**PUBLIC WORKS STANDARDS, INC. – GREENBOOK COMMITTEE  
MEETING AGENDA -  
MAY 17, 2022**

Proposed Revision To: <input checked="" type="checkbox"/> <b>Standard Specifications For Public Works Construction</b> <input type="checkbox"/> <b>Standard Plans For Public Works Construction</b>	<b>Change No.</b> <b>322 SM</b> <small>(ASSIGNED BY GREENBOOK COMMITTEE)</small>
Public Works Standards, Inc. c/o Associated General Contractors of California Los Angeles District Office 1906 West Garvey Avenue, Suite No. 100 West Covina, California 91760	<b>Date Proposal Received</b> <b>04/19/22</b> <small>(ASSIGNED BY GREENBOOK COMMITTEE)</small>
<b>Subsection or Standard Plan to be revised: 210-1.2.5</b> <b>On page(s): 58, 61, &amp; 64 (2021 Ed.)</b>	
<b>Warning:</b> Public Contract Code §3400 prohibits any local agency specification that limits bidding, directly or indirectly, to any one specific concern or product. If this revision describes a proprietary or patented product, it must identify other products which equally perform the functions of the proprietary or patented product.

<b>Revision:</b> Add language to allow the use of blended cements under ASTM C595	
<b>Reason For Revision:</b> Blen

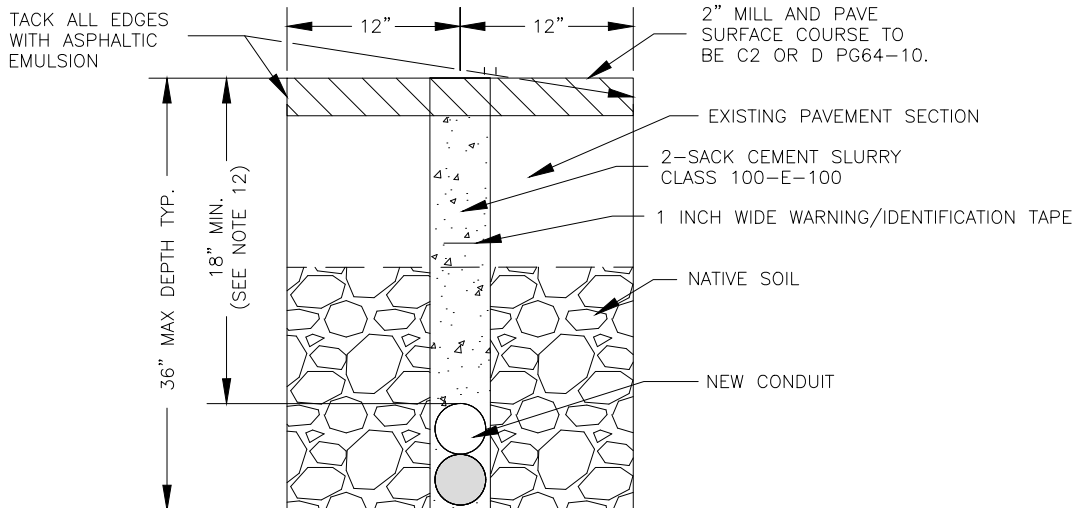
**a) Blended Cement.** ~~Blended cements shall be Type IP (MS) Portland pozzolan conform to ASTM C595, unless otherwise specified. Blended cements shall be Moderate Sulfate Resistant (MS) or High Sulfate Resistant (HS.) Type IP (MS) cement shall meet the optional mortar expansion requirements of ASTM C595, Table 2 and contain no more than 25 percent pozzolan. The alkali content in the cement portion of Blended cements must not exceed 0.60 percent by mass of alkalies as Na<sub>2</sub>O + 0.658 K<sub>2</sub>O when determined under AASHTO T 105. Maximum limits on pozzolan content do not apply.~~
